UNITED STATES PATENT AND TRADEMARK OFFICE

| APPLICATION NO. | FILING DATE | FIRST NAMED INVENTOR | ATTORNEY DOCKET NO. | CONFIRMATION NO. |
|-----------------|-------------|----------------------|---------------------|------------------|
| 10/786,957 | 02/25/2004 | Kevin C. South | 8017-446/ FG-4581 | 3789 |

NON-FINAL OFFICE ACTION

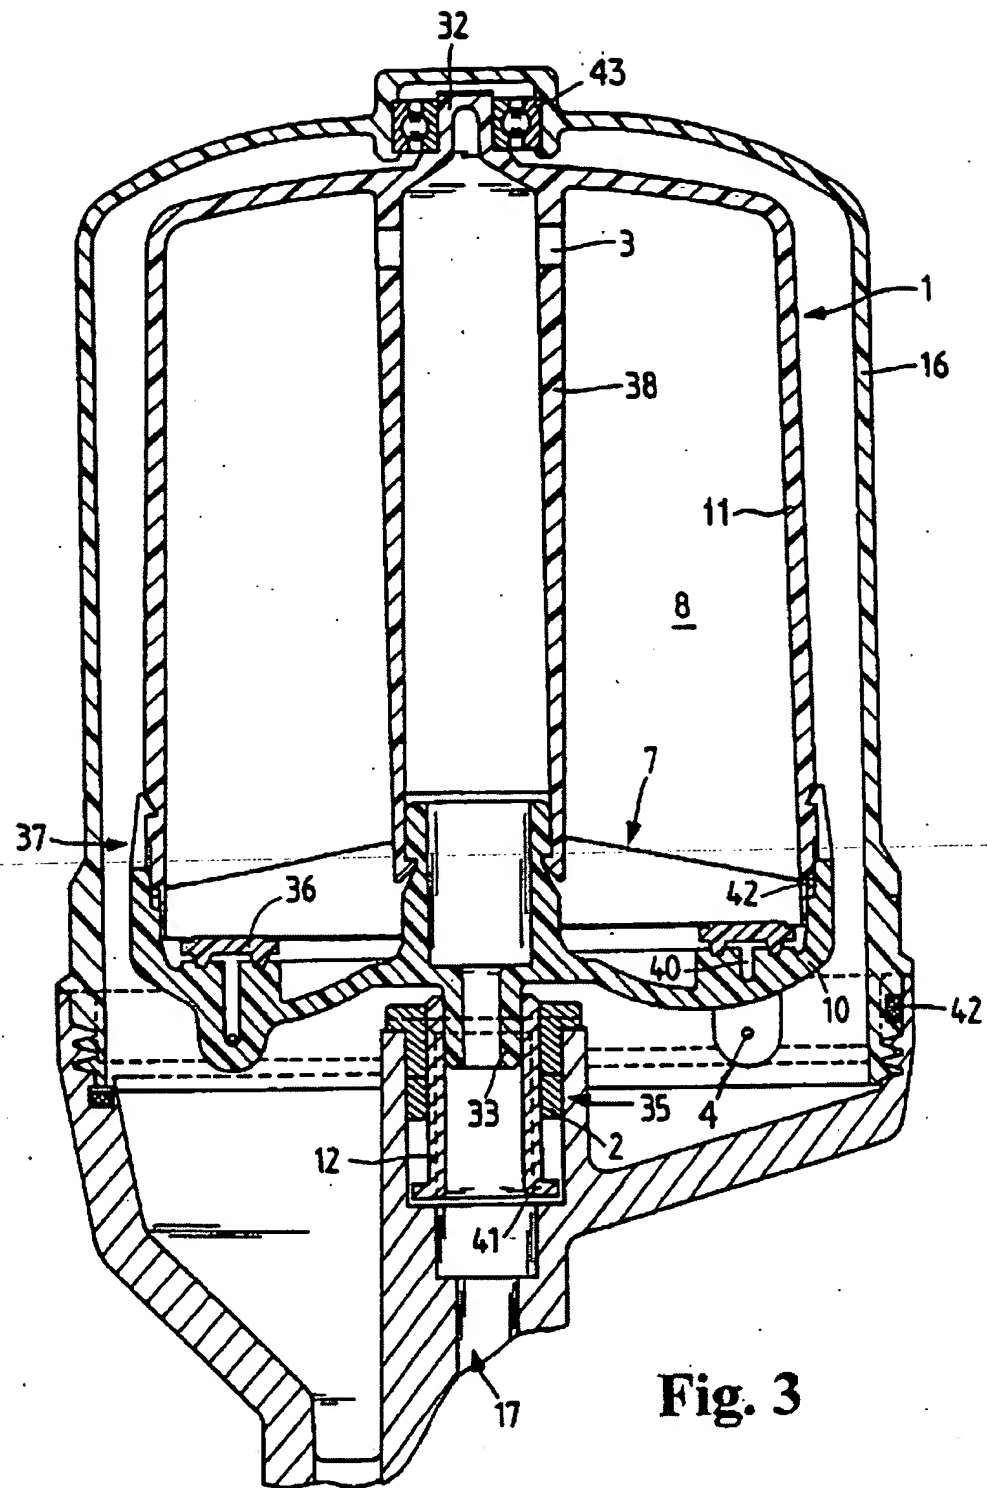
4. Claims 12-13 are rejected under 35 U.S.C. 102(b) as being anticipated by Frehland et al. (US 6,224,531 B1).

The patent to Frehland et al. '531 discloses as seen below a centrifuge rotor for fluid processing comprising a plastic first rotor portion 11; a plastic first rotor shaft spud 32 joined to said first rotor portion; a plastic second rotor portion 10 joined to said first rotor portion to define a rotor interior; a plastic baseplate 36 positioned in said rotor interior and being received by said second rotor portion; a plastic second rotor shaft spud 33 joined to said second rotor portion and defining a bearing surface extending beyond said second rotor portion, said first rotor shaft spud having a bearing surface that is coaxially aligned with the bearing surface of said second rotor shaft spud (Fig. 3) and a fluid processing element 7 positioned in said rotor interior; a fluid bore (within 33 - Fig. 3).

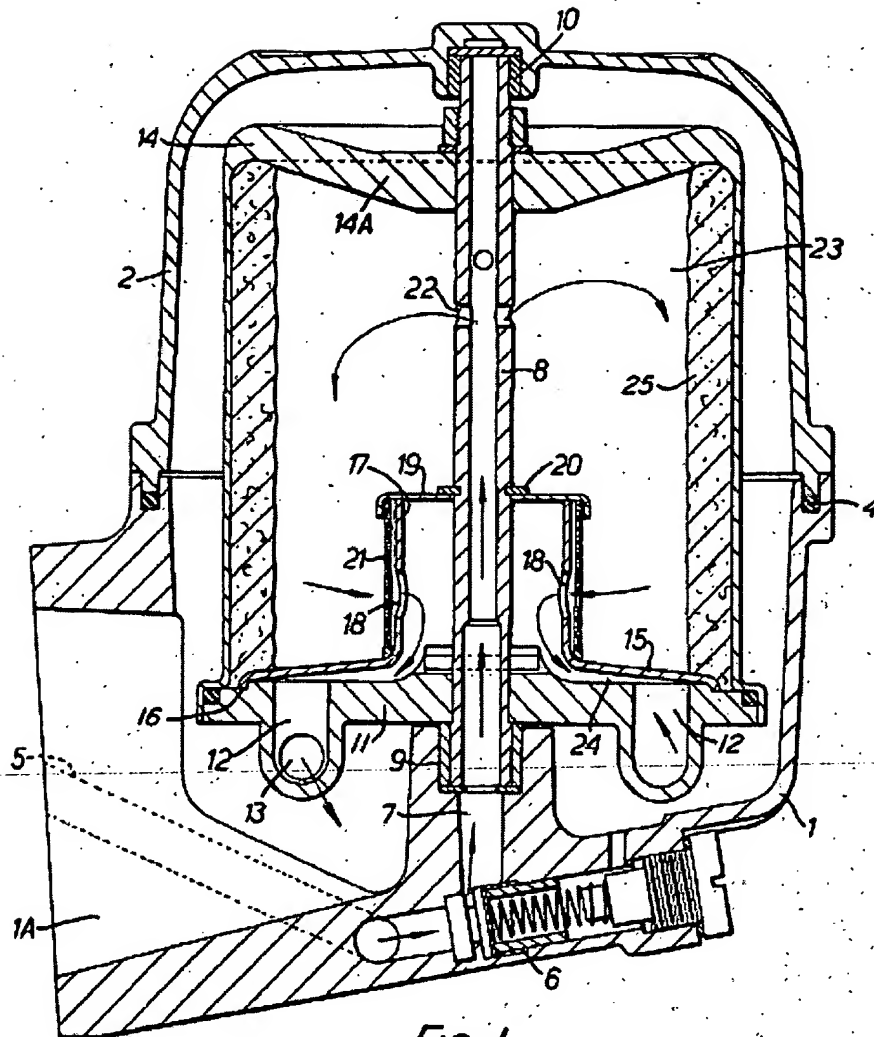
5. Claims 1, 9, 10, and 11 are rejected under 35 U.S.C. 102(b) as being anticipated by Beazley (US 3,432,091).

The patent to Beazley '091 discloses in Fig. 1 as seen below a centrifuge rotor for fluid processing comprising a centrifuge rotor for fluid processing, said centrifuge rotor comprising a first rotor portion 14A including a first rotor shaft spud (proximate 10); a second rotor portion 11 joined to said first rotor portion to define a rotor interior; a baseplate 15 positioned in said rotor interior and being received by said second rotor portion, said baseplate 15 including a second rotor shaft spud (proximate 9) extending through and beyond said second rotor portion; and a fluid processing element 21 or 25 positioned in said rotor interior; wherein said first rotor shaft spud defines a fluid bore; wherein said second rotor shaft spud defines a fluid bore; wherein said first rotor shaft spud includes a first bearing surface (that abuts 10) and said second rotor shaft spud includes a second bearing surface (that abuts 9) that is coaxially aligned with said first bearing surface.
